**STAFF REPORT**

| <b>File Number</b>          | PL 15-126                           | <b>Contact</b>                  | Jenn Reed Moses, jmoses@duluthmn.gov |

The applicant is requesting a MU-W Planning Review for a new 70-unit hotel with a 900 square foot convenience store.

Re: AmericInn Hotel  
Minnesota Avenue  
Duluth, MN  
Review of Zoning Section 50-30

M-6

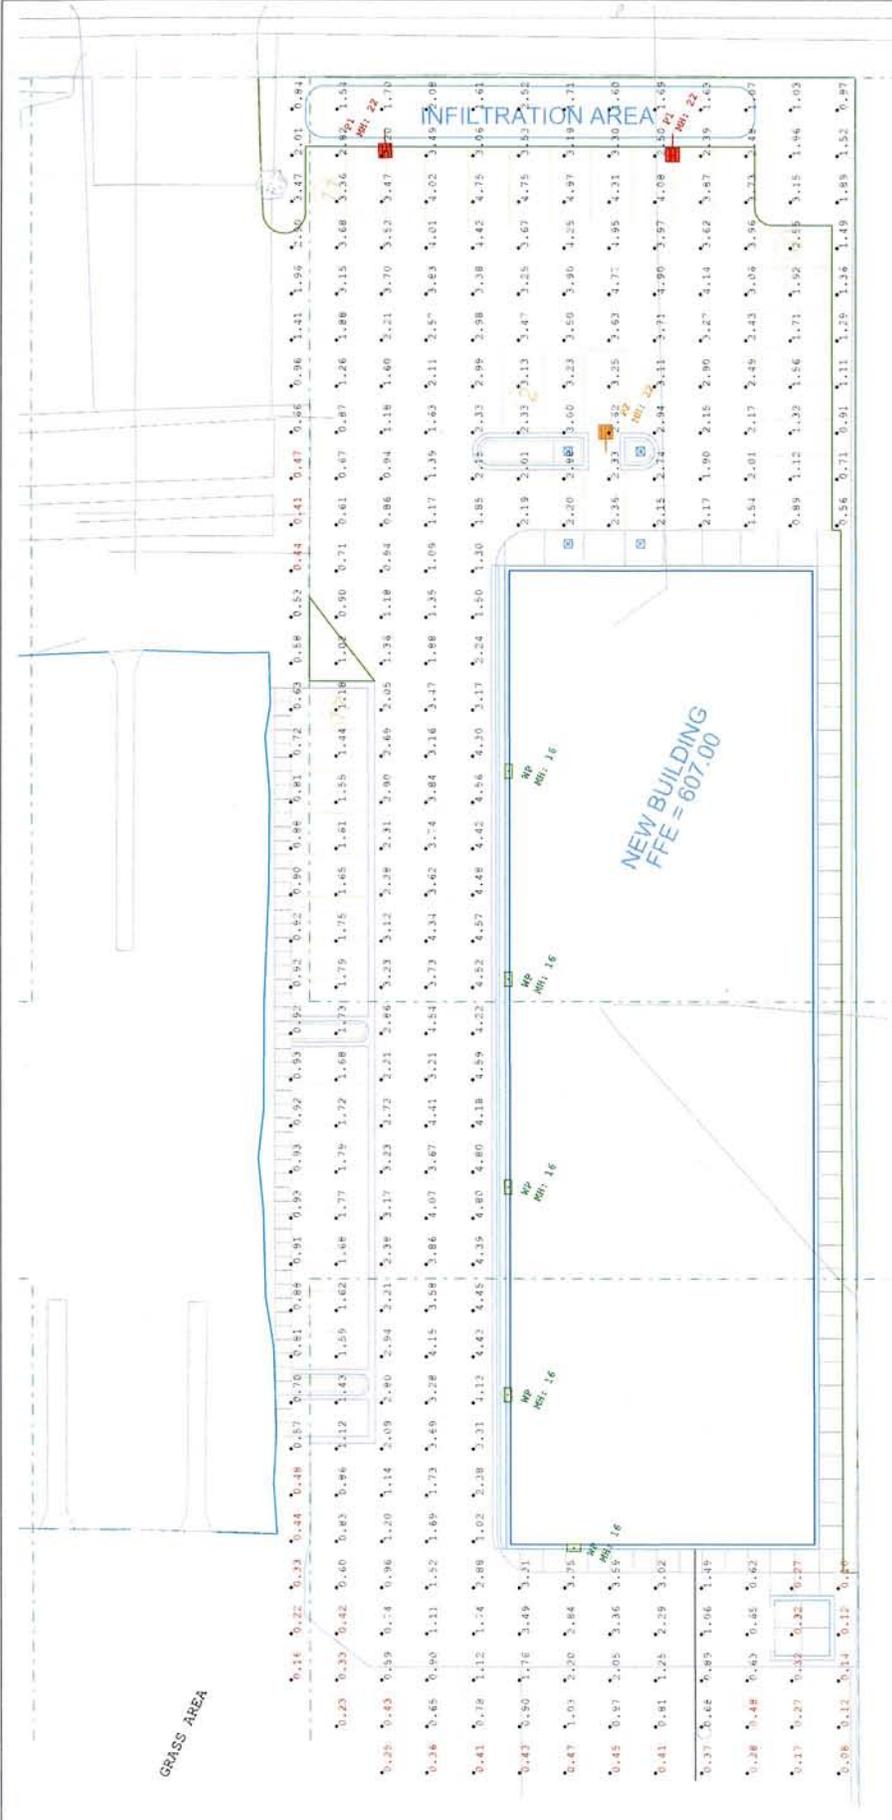
- 10.) 50-30 (Building Design Standards) - Project meets building design standards, as iterated in the applicant's memo.
- 11.) 50-31 (Exterior Lighting) - Light fixture information submitted with the application shows full cut-off fixtures that meet UDC requirements. Photometric plan shows elevated light levels at the southeast property line.

- 1.) The project be limited to, constructed, and maintained according to "Exterior Elevations," dated 08/26/15; "Landscape Plan," dated 08/04/15; "Paving and Dimension Plan," dated 08/26/15; and Photometric Plan, dated 08/25/15.
- 2.) If the variance is not approved by the Planning Commission, the applicant revise the plan to show compliance with shoreland setbacks.
- 3.) Landscape Plan be revised to show compliance with 10% interior landscaping requirement.
- 4.) Photometric plan be revised to show compliance with exterior lighting requirements.
- 5.) Any alterations to the approved plans that do not alter major elements of the plan may be approved by the Land Use Supervisor without further Planning Commission; however, no such administrative approval shall constitute a variance from the provisions of Chapter 50.

2 EAST EXTERIOR ELEVATION  
1/8" = 1'-0"

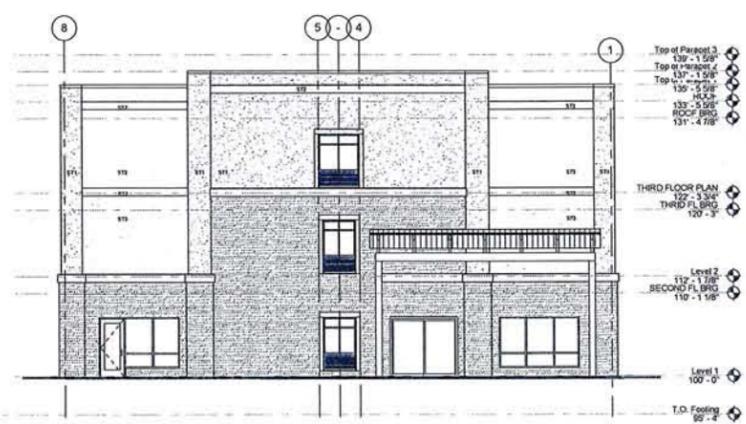
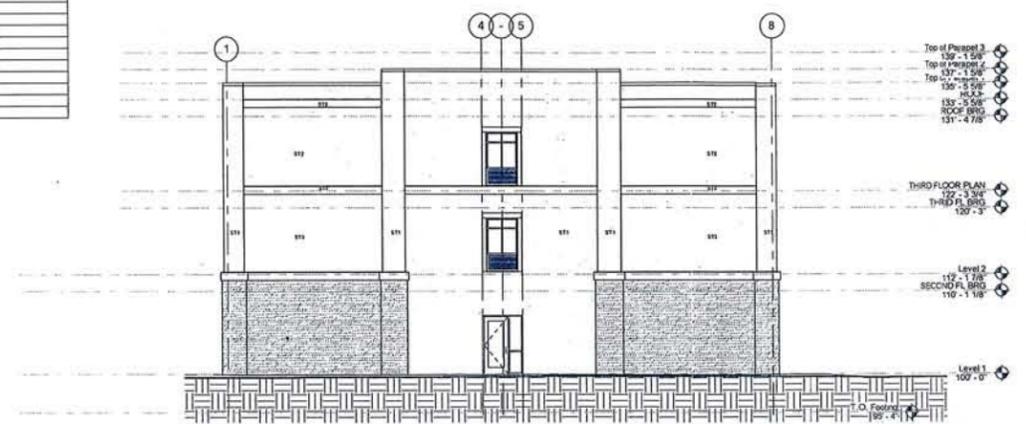
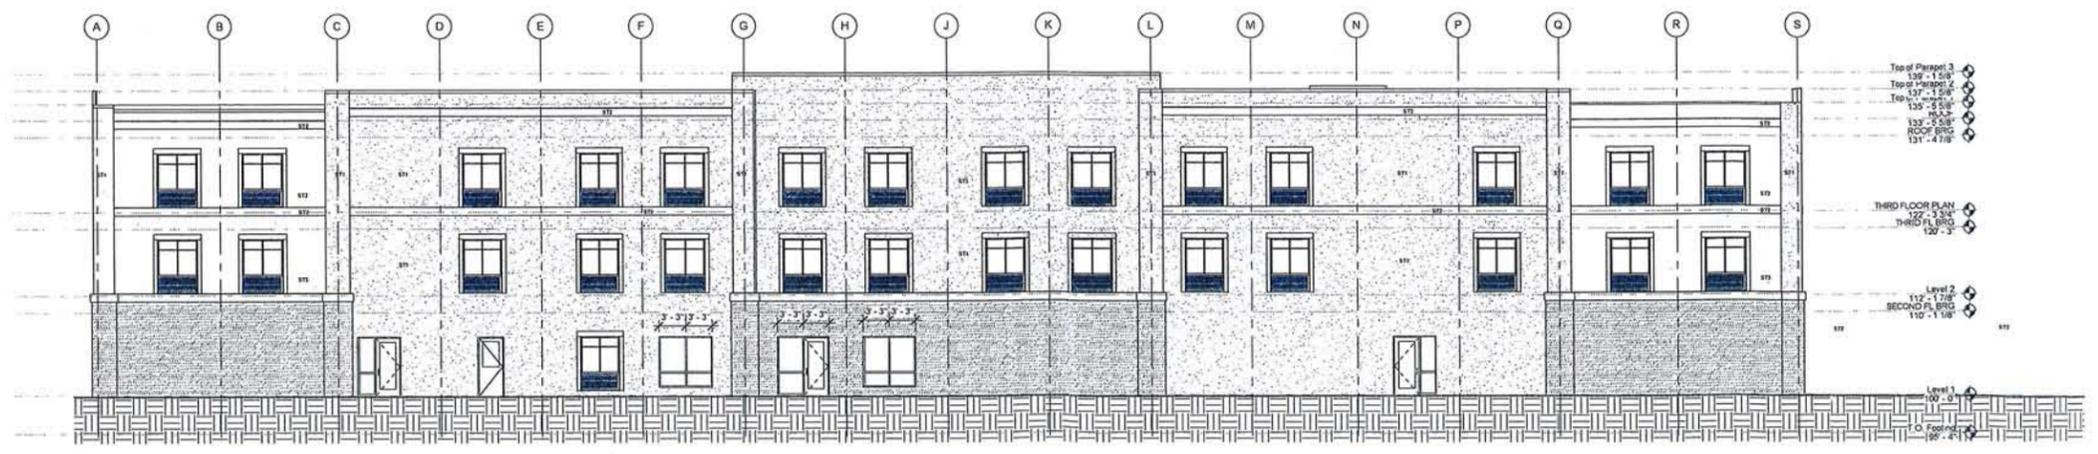
- 50-30.2, A This development meets the minimum standards of this section as the hotel has more than 10,000 square feet of floor area.
- 50-30.2, B
1. Transparency Requirement. The East Façade has 2,546 square feet of wall area. 10% of that area, 254.6 sq. ft., needs to be windows. This façade has 393 sq. ft. of window. 5% of the façade, 127.3 sq. ft., needs to be on the first floor and no higher than 4 feet above sidewalk. The first floor windows have 243 square feet of area.

2. Wall Plane Articulation Option. The north and south facades of this building fall under these requirements. Each of these facades incorporates brick and stucco finishes, with three different colors of stucco. There are bumped out piers dividing each portion of the façade for articulation.

3. Vertical Articulation Option. Each of the four facades incorporates banding and change of materials to provide generally a vertically divided façade. The use of a brick base with alternating colored stucco upper portions separated by stucco bands adequately articulates these facades vertically.

4. The facades have typically three levels of top of parapet relating to the individual portions of the façade. The steps up are less than the required 3 foot as the design attempts to remain lower to meet other recommendations of the zoning ordinance.

5. Foundation Landscaping Option. Because of the nature of this development, the sidewalk abuts the east façade for ease of access from the parking stalls to the entry doors.

- 50-30.2, C Entryway Design and Location. The entry for this hotel will be readily understood with the use of the Porte Cochere, which includes a canopy (1), a roof overhang (2), and an arch (4).
